STATE OF
COLORADO

COGCC Form 2A review of Bonanza Creek's Whitetail F-4 Pad location - Doc #400732657

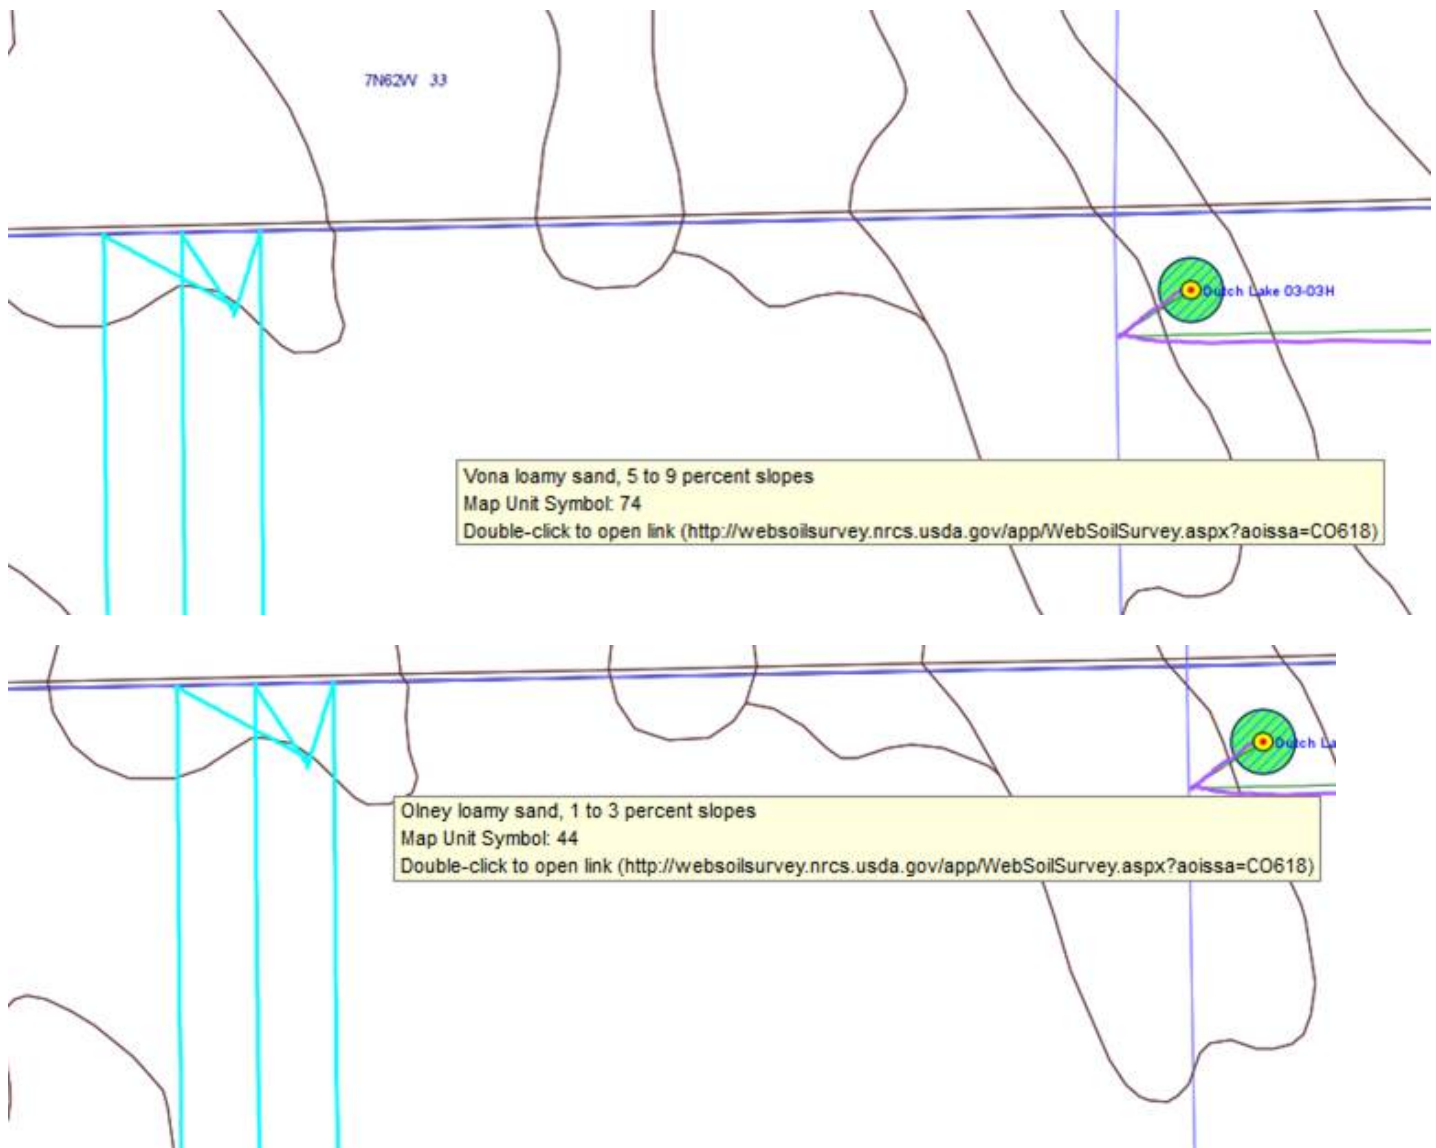
1) In the Related Remote Locations section you have indicated the wells on this proposed oil and gas location will produce to your Crow Valley CPF O-32 Pad location (Location ID #440295 / Form 2A Doc #400723381). However, in the Facilities section you have also listed a large number of production facilities on this proposed location. This is rather confusing and excessive. The way this Form 2A has been submitted, it appears as if Bonanza Creek has not decided on a course of action for where these proposed oil and gas wells will produce to. The 2A process is not intended to permit multiple new locations/surface disturbances for the development and production of the same oil and gas wells. The COGCC is looking to Operators to consolidate both their oil and gas wells and production facilities into as few locations/surface disturbances as possible and then submit a Form 2A that demonstrates this plan. Please provide clarification and explanation as to why this proposed location is being submitted to produce the oil and gas wells to multiple locations.

This is really for future planning and goes along with that bearing of the OGLA process. Centralized production facilities result in the least amount of surface disturbance and the facilities on location are planning for upset conditions, changes in planning, and other unforeseen circumstances that will make a separate CPF untenable. The following is a narrative from our Facilities Manager, Steve Grigel, on his rational in designing and permitting in this fashion.

BCEI is working to consolidate its oil and gas facilities when and where possible for the multiple benefits. In this case, there was some uncertainty regarding the availability of a central CPF location and an alternate on-site location was conceptualized. Obviously, we do not want to build excessive facilities or land disturbance and will build the facilities accordingly.
